7/30/2014 Recommendation Meeting
Queen Anne Mixed Use - 531 Queen Anne Ave. N., Seattle, WA 98109
DPD PROJECT #3014863

TABLE OF CONTENTS

lighting fixtures and lighting plan

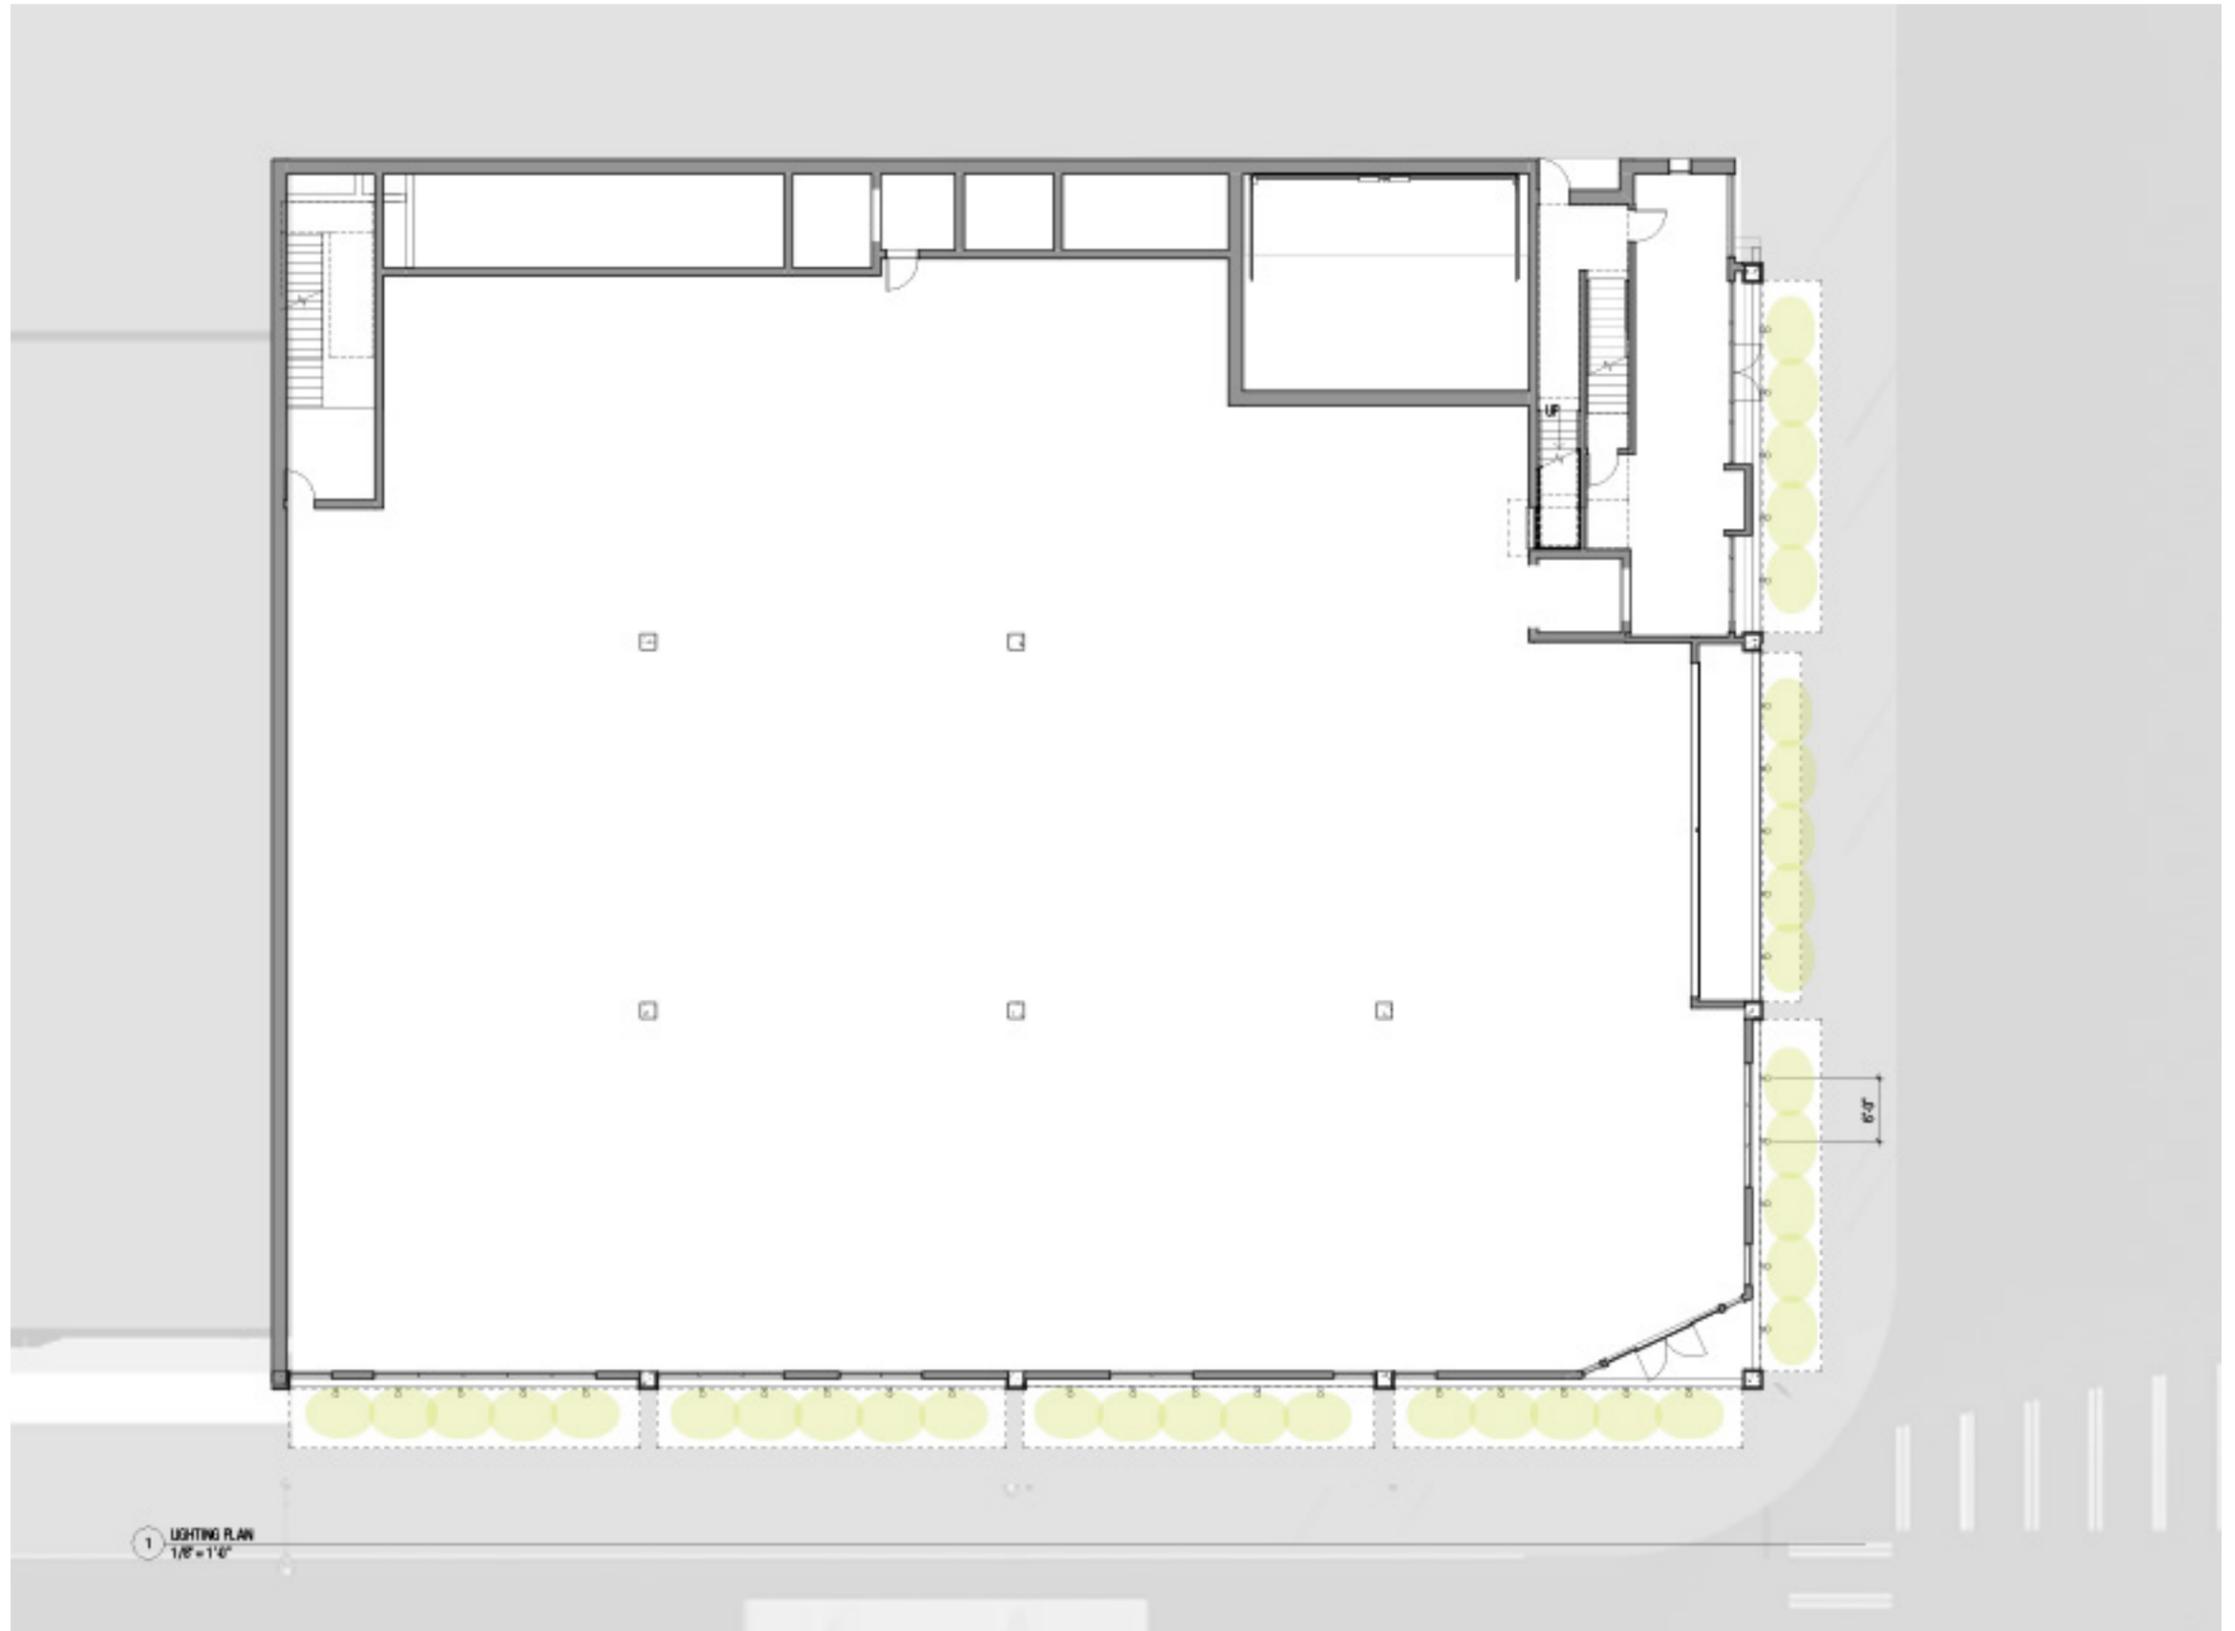
EDG Meeting # 2: Provide a lighting plan at the Recommendation meeting. A rendering of the building at night would also assist the public and the Board in their evaluations.

Applicants Response: Plan and fixture cut-sheets provided, as well as a night-time rendering. The “Uptown” sign will not be illuminated, and instead will have cut-out letters, allowing ambient light to shine through. This will limit impact of lighting on apartment residents.

signage

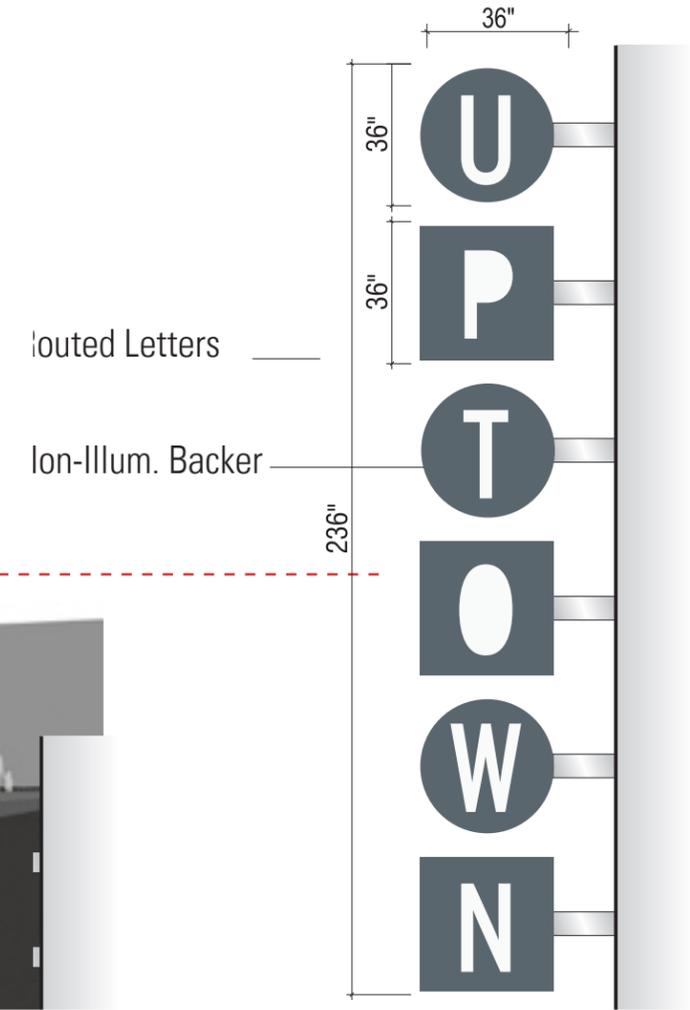
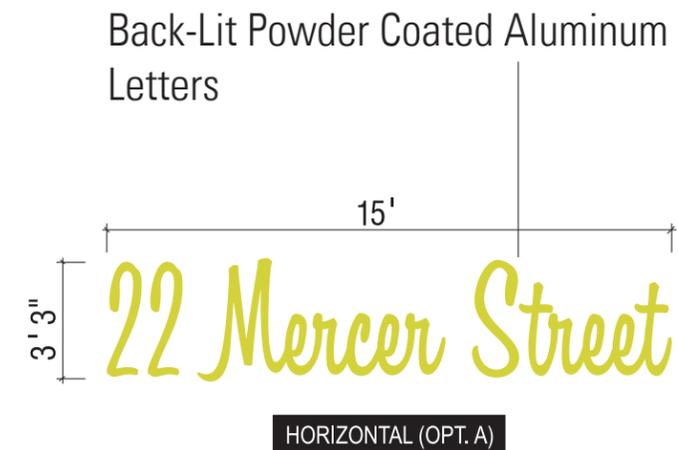
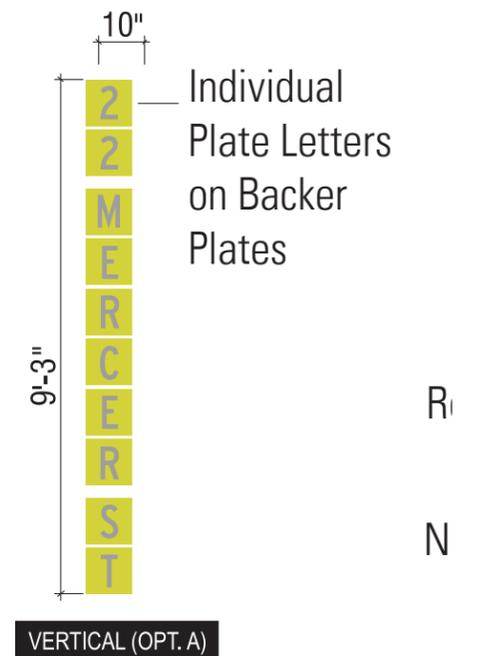
EDG Meeting #1: Present a signage concept plan detailing the size and location of the tenant’s signage at the Recommendation meeting.

EDG Meeting # 2: A detailed signage plan will need to be presented at the time of the MUP application intake appointment. The Board encouraged integrating signage into the architecture and fully complying with the Uptown neighborhood specific guidelines above. Board members endorsed corporate signage no larger than 36 inches high and an Uptown vertically oriented blade sign.

Applicants Response: All proposed signage -- with the exception of the micro-retail -- is represented in the renderings. A vertically oriented, “Uptown” blade sign is proposed at a larger scale than the retail signage. Dimensioned elevations are also provided, as well as the color palette. Micro-retail signage design will be in character with “Uptown” or apartment signage, once a tenant had been identified.
